# **A G E N D A**

## **Architectural Review Board**

**March 22, 2016**

ADDITIONS/RENOVATIONS TO  
115 HANRICK STREET

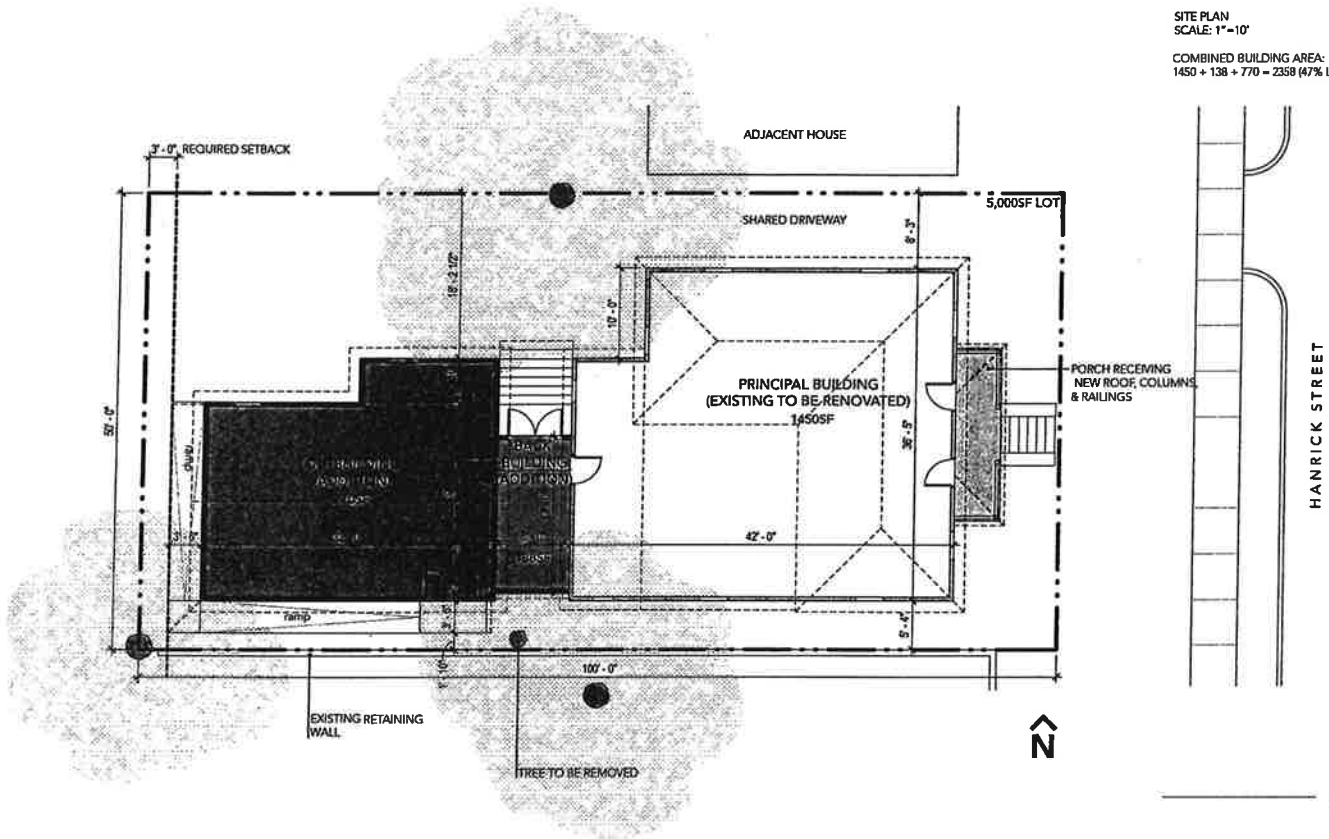
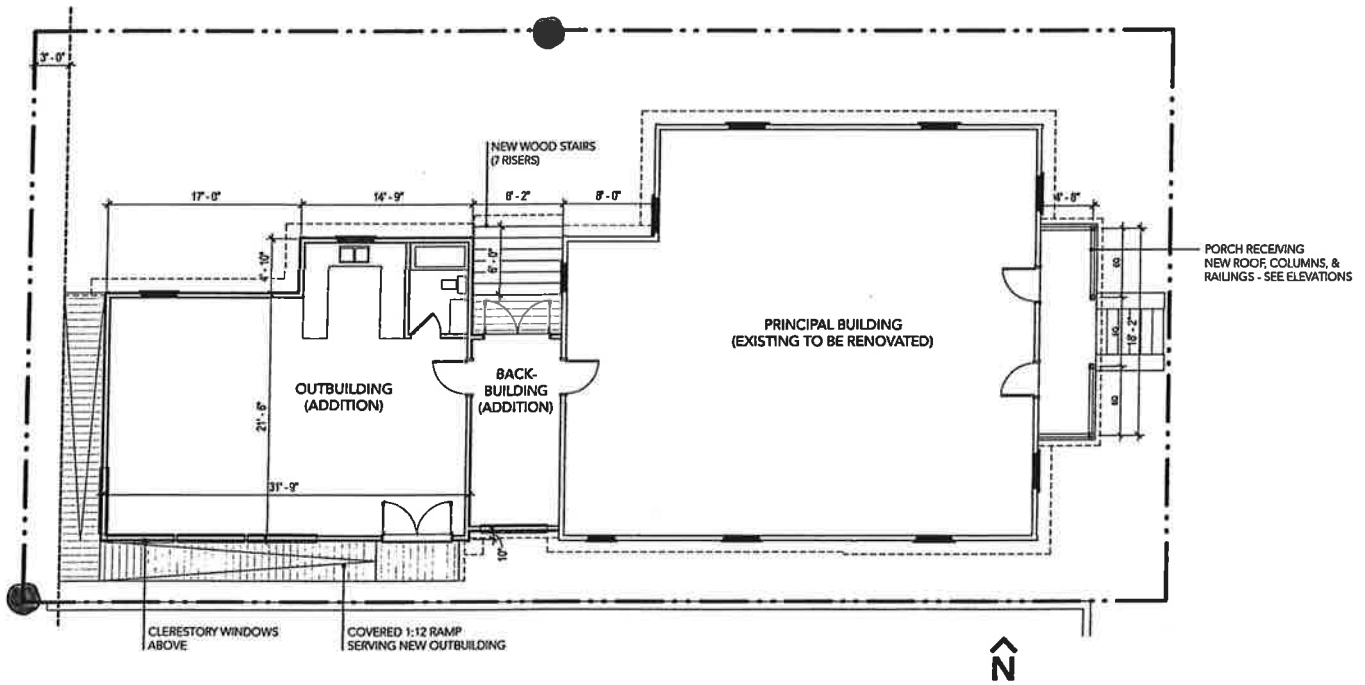
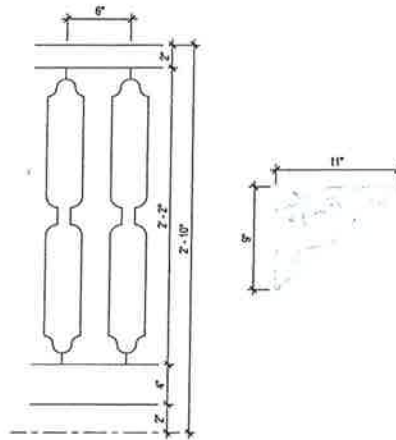
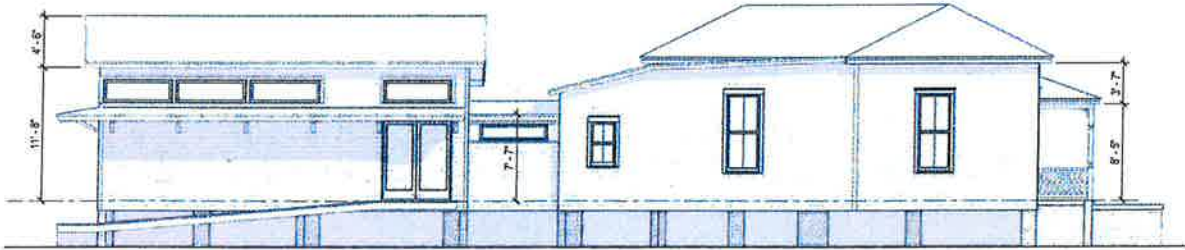
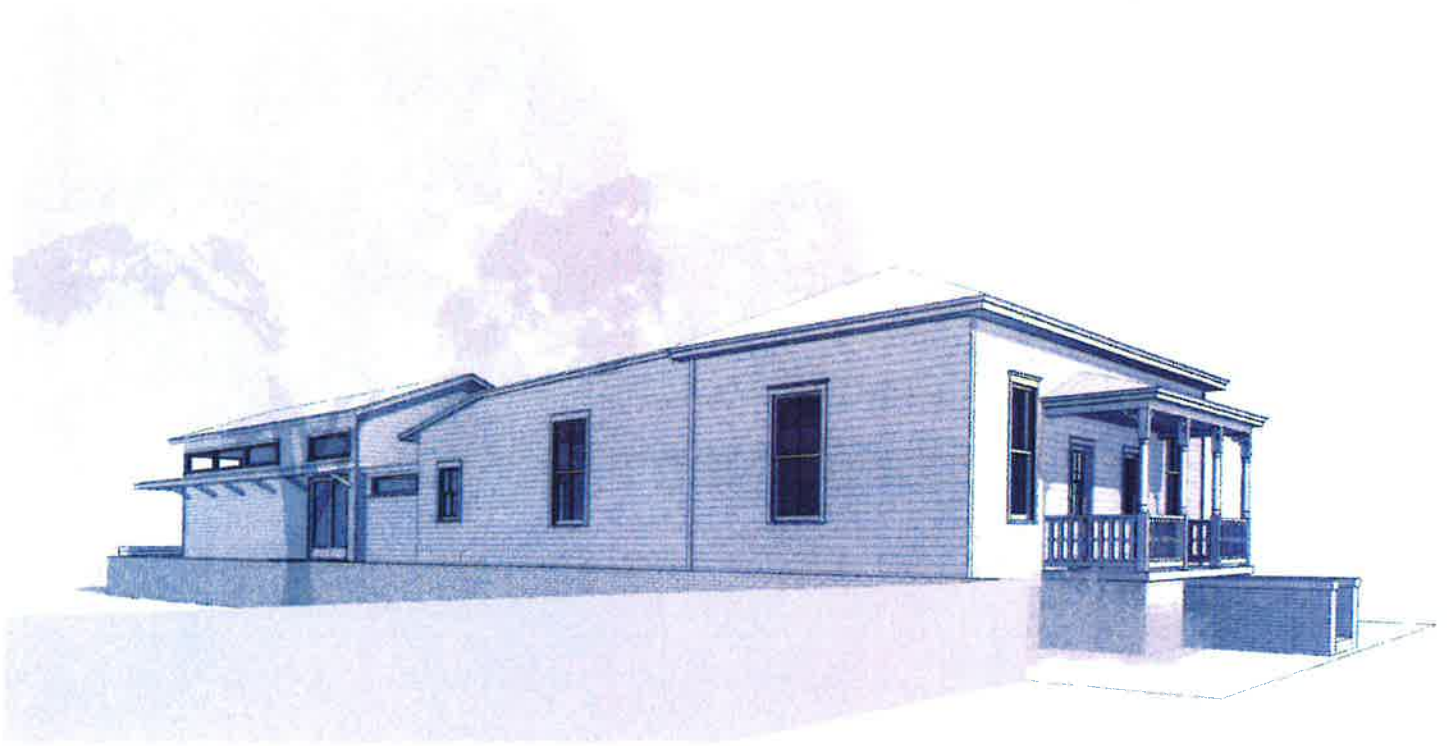
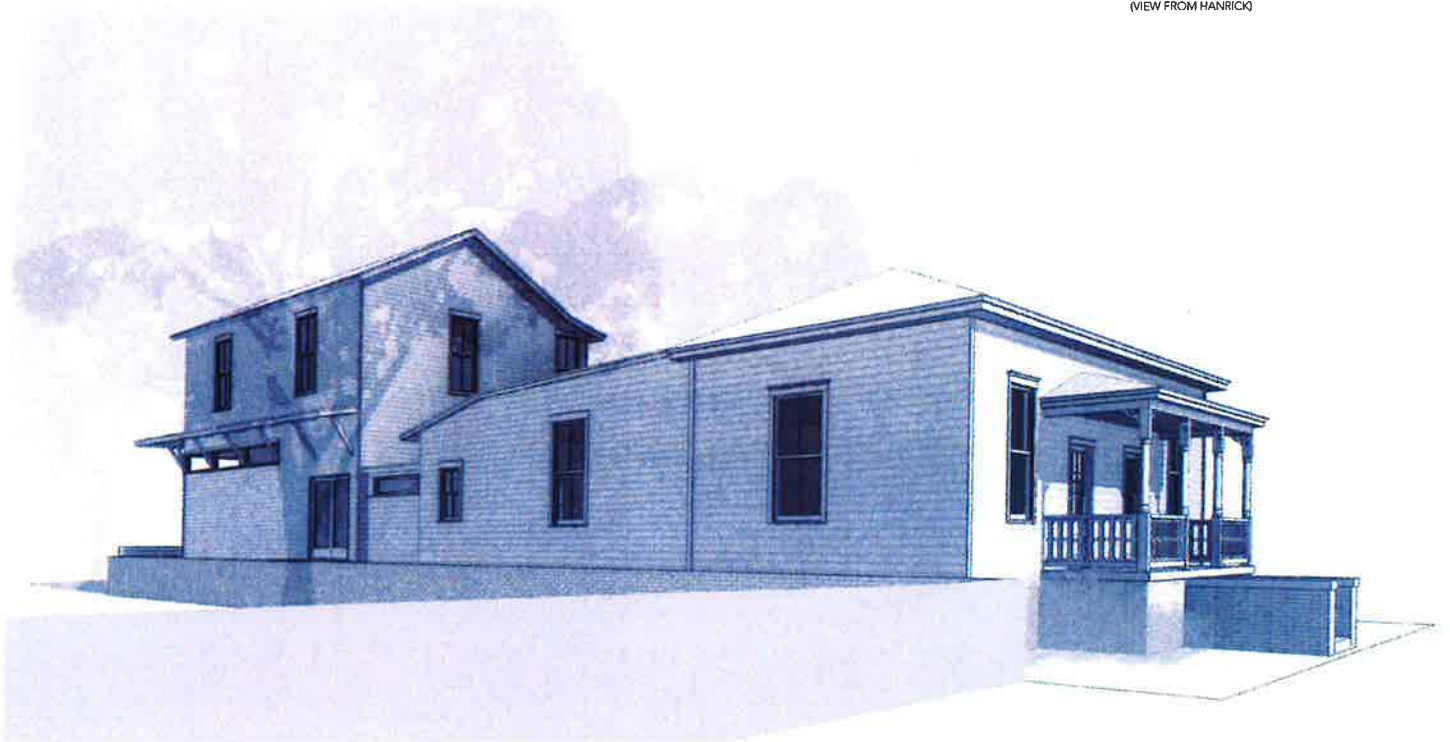
- The submission was approved by Hickman, Bush, Foshee, Campbell, Payne, Hayden, and Welch (Brown was absent)
- A copy of the approval letter is attached.

After thorough study and consideration of this application, the Board approved the request as presented for both options. ARB approvals are valid for one year.
